DECISION, FINDINGS OF FACT AND CONCLUSIONARY FINDINGS OF THE MCMINNVILLE HISTORIC LANDMARKS COMMITTEE FOR THE APPROVAL OF ALTERATIONS TO A HISTORIC LANDMARK LOCATED AT 608 NE 3RD STREET

- **DOCKET:** HL 7-20 (Certificate of Approval for Alteration)
- **REQUEST:** Approval of alterations to an existing historic landmark and building that is listed on the McMinnville Historic Resources Inventory as a "Distinctive" historic resource (resource number A866), and is also a contributing building to the McMinnville Downtown Historic District. The proposed alteration includes the addition of two louver vents on the alley (south) façade of the building to provide necessary ventilation for a restaurant use within the building.
- **LOCATION:** 608 NE 3rd Street. The property is described as Lot 4 and the West ½ of Lot 3, Block 6, Rowlands Addition. The property is also identified as Tax Lot 10400, Section 21BC, T. 4 S., R. 4 W., W.M.
- **ZONING:** C-3 (General Commercial)
- **APPLICANT:** Ernie Munch, on behalf of property owner Historic 3rd and Ford LLC

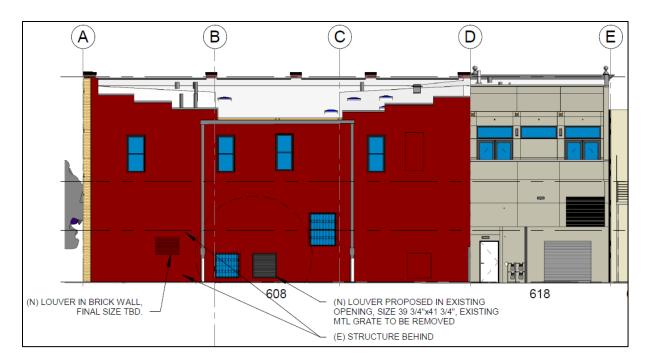
FINDING: SATISFIED WITH CONDITION #1. The City partially concurs with the applicant's findings, in that the louvers are proposed to be finished in a manner that blends in with the existing alley (south) façade and therefore will be visually compatible with the remainder of the building.

The City clarifies that the proposed alteration to add the two louvers to the building façade is not necessary to stabilize, consolidate, or conserve existing historic materials or features. However, the proposed method of construction for the louver that will be placed within an existing window opening will allow for the addition of one of the louvers without a new opening in the building wall. As proposed to be constructed in the details provided on Sheet SD-4, the proposed louver

within the existing window opening could be removed in the future and the window reestablished, should the internal use of the building no longer require the ventilation provided by the louver. This will ensure that property is recognized in its physical form at the time of the introduction of the new use (the restaurant within the building), and the documentation of the existing window that will be replaced with a louver within the application materials will provide documentation for any future conversion back to a window.

A condition of approval is included to require that the louvers be finished as proposed in the application narrative. Specifically, the louver that will be in a new opening in the building façade shall be constructed as identified on Sheet SD-5 and shall be painted to match the color of the surrounding stucco on the building façade. The louver that will be in the existing window opening shall be constructed as identified on Sheet SD-4 and will be painted to match the color of the remaining windows on the south building façade.

That the louvers shall be finished as proposed in the application narrative and application materials. Specifically, the louver that will be in a new opening in the building façade shall be constructed as identified on Sheet SD-5 and shall be painted to match the color of the surrounding stucco on the building façade. The louver that will be in the existing window opening shall be constructed as identified on Sheet SD-4 and will be painted to match the color of the remaining windows on the south building façade.
